TOWNSHIP OF NORTH BRUNSWICK
710 HERMANN ROAD
NORTH BRUNSWICK, NJ 08902

MEMORANDUM

SUBJECT: Block: 140 Lot: 60.01 **Second Review**
Street Address: 901-993 State Route 1 North Brunswick, NJ 08902
Applicant: 901-99 North Brunswick, Land Holdings, LLC

This review supplements my previous review dated January 19th 2023, and is submitted based upon amended plans revised 3/13/2023 by Apex Design & Engineering Group. The applicant states the site plan was amended to reduce the number of variances.

Figure 1: Subject property (aerial view)

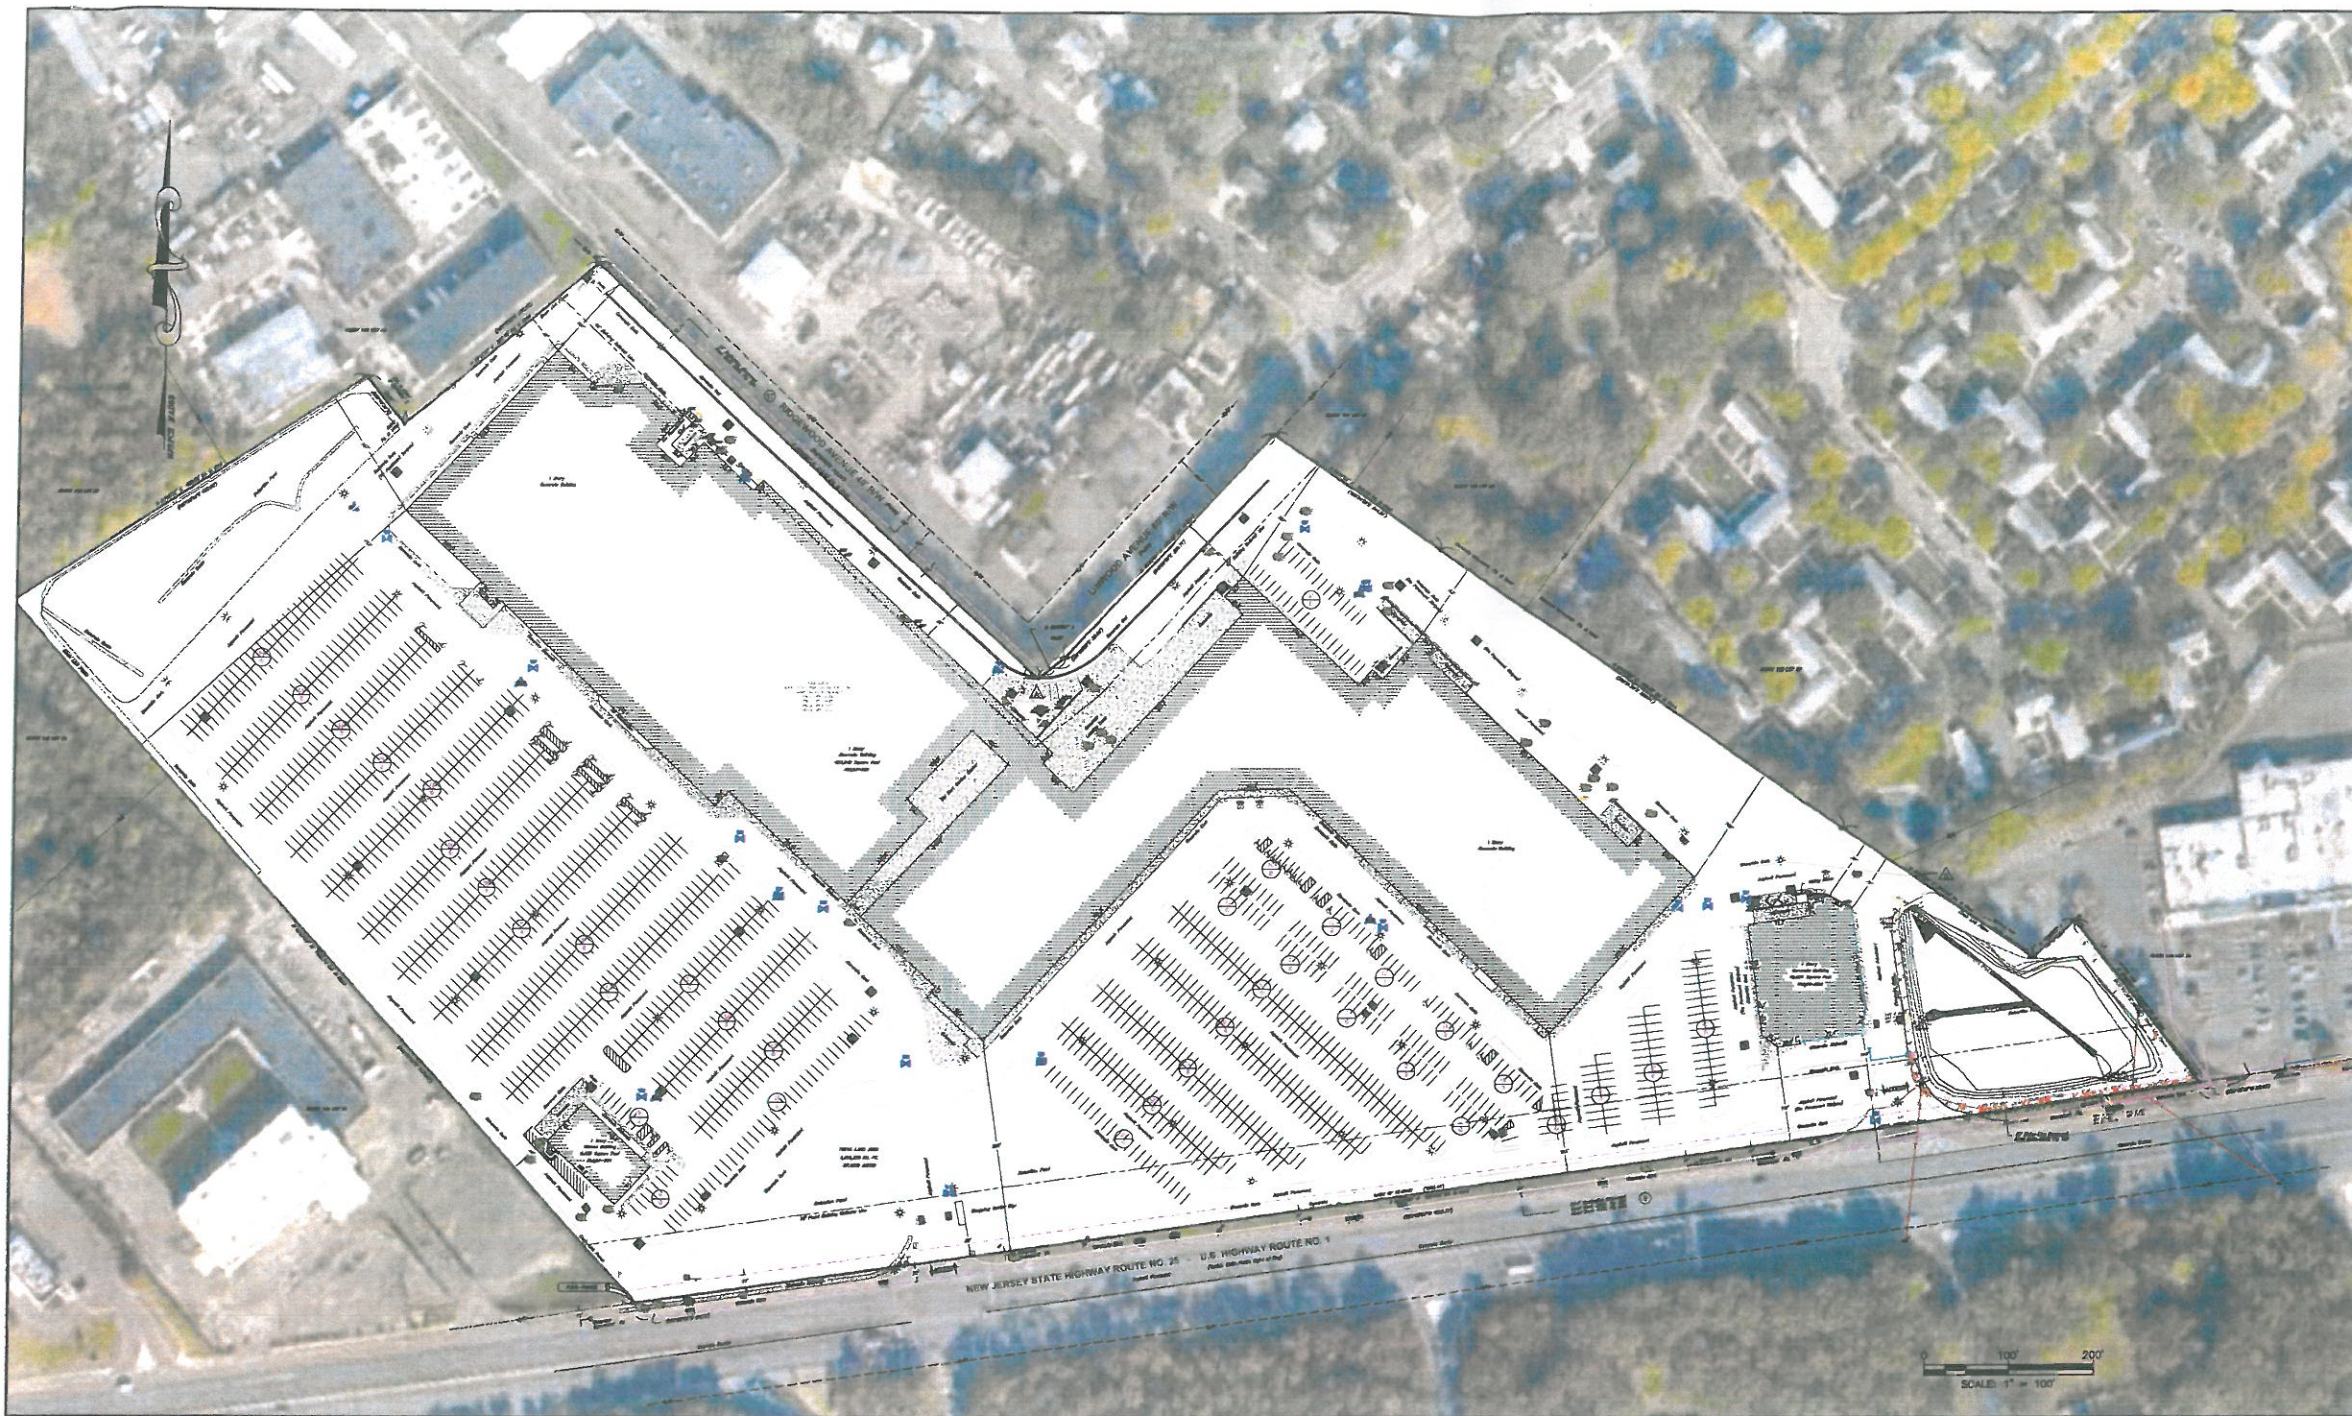
The subject property falls within the area of an existing detention basin. The basin is located on the southbound side of State Highway Route 1 in the C-2 (General Commercial Zone), between Kimco Plaza (PetSmart) and North Village Mall (Staples). The applicant determines schedule of yard area requirements based upon both Kimco and North Village shopping centers. Testimony should be

provided as to why both shopping centers are used and not solely Kimco Plaza when determining calculations.

The total area encompasses 1,616,333 square feet or 37 acres. The area of the detention basin or disturbed area is 27,120 SF (0.623 acres). The C-2 zone permits freestanding signs (ordinance 205-105), but prohibits billboards (ordinance 205-105 (I)). Billboards are only permitted in the I-1 Industrial Zone.
